# ORIGINATION FORM

Index Number: 830-T01  
Sheet Number (s): 2 of 2  
Index Title: Railroad (Grade) Crossing

## Summary of the changes:

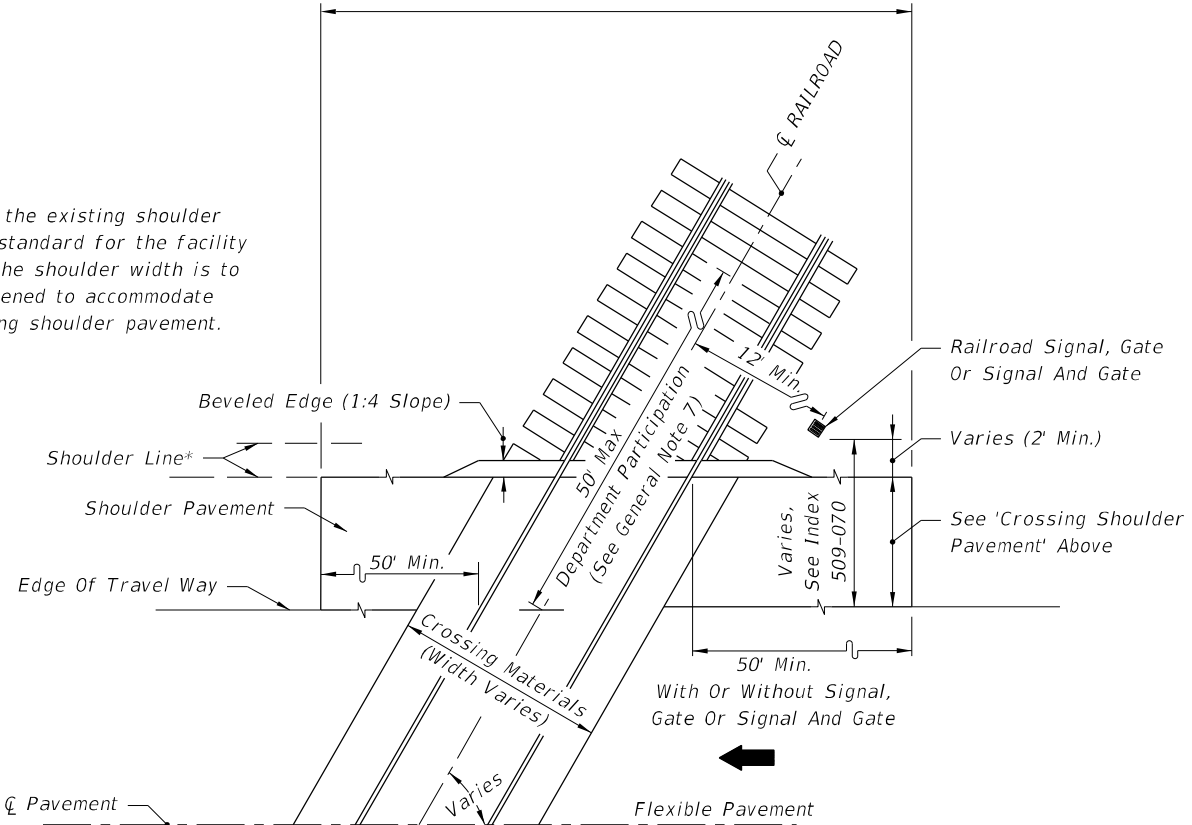
CSX is interpreting the current label of shoulder pavement as only asphalt. CSX is requiring the District to write a variance to place concrete in the area labeled shoulder pavement when adjacent to concrete sidewalk. I have attached a picture of what is typically built.

HALF PLAN  
CURBED ROADWAYS

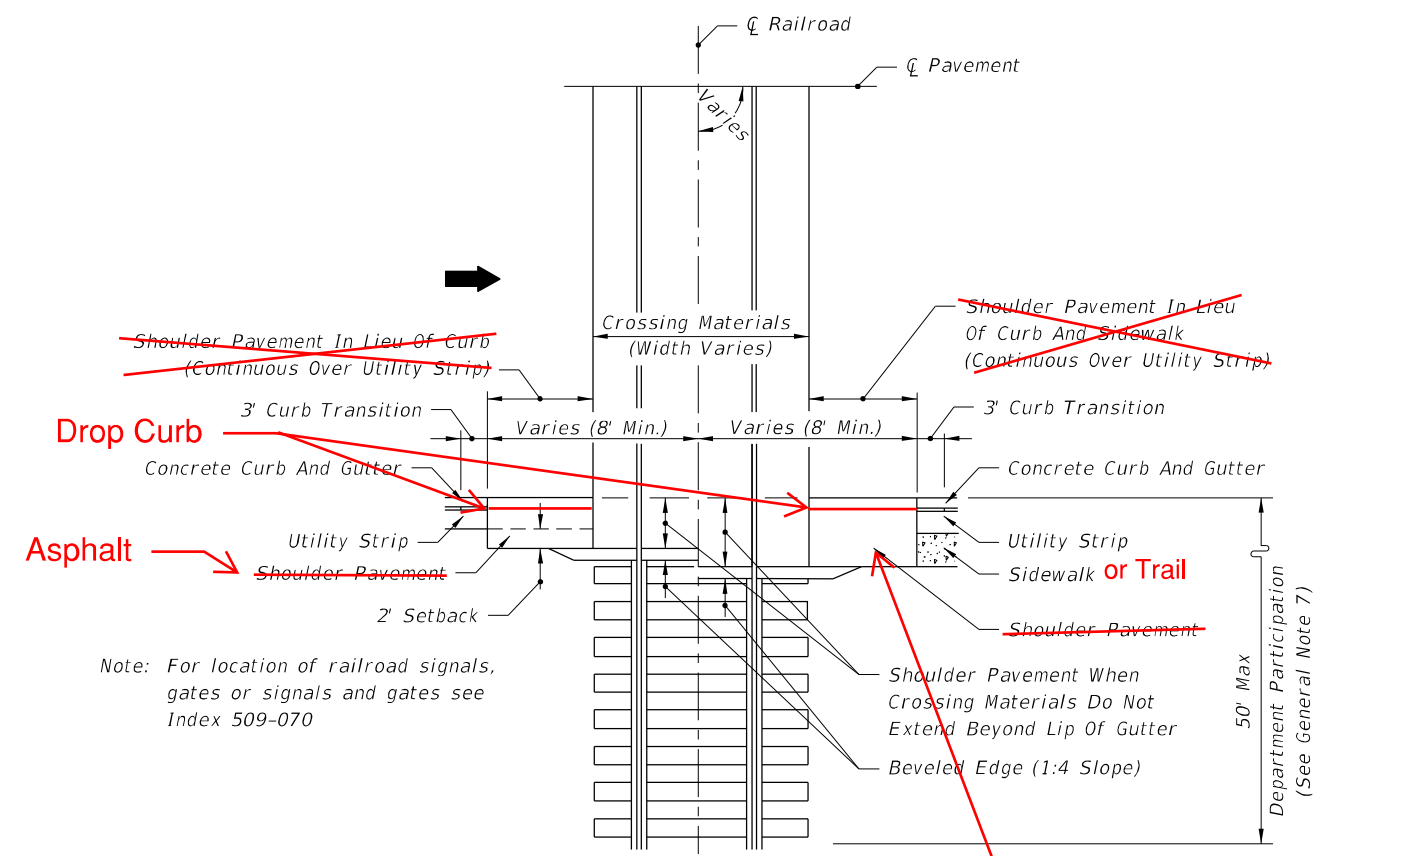
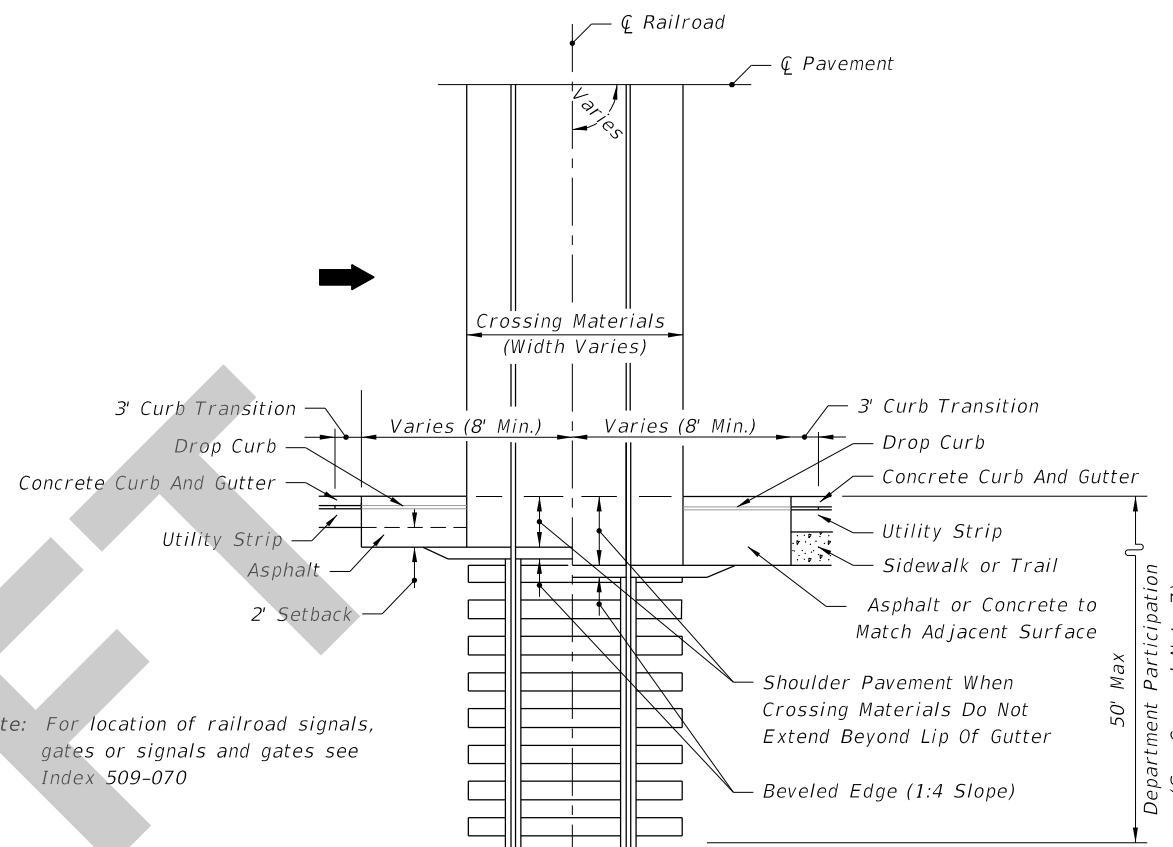
Add a line indicating the curb continuing to the junction with the crossing. Remove the label about shoulder pavement in lieu of curb. Add a label for drop curb. Modify label "shoulder pavement" to "asphalt pavement" on the left half. Add "or trail" label to sidewalk on right half. Change "shoulder pavement" on right to asphalt or concrete pavement to match adjacent surface.

Asphalt or Concrete to Match Adjacent Surface
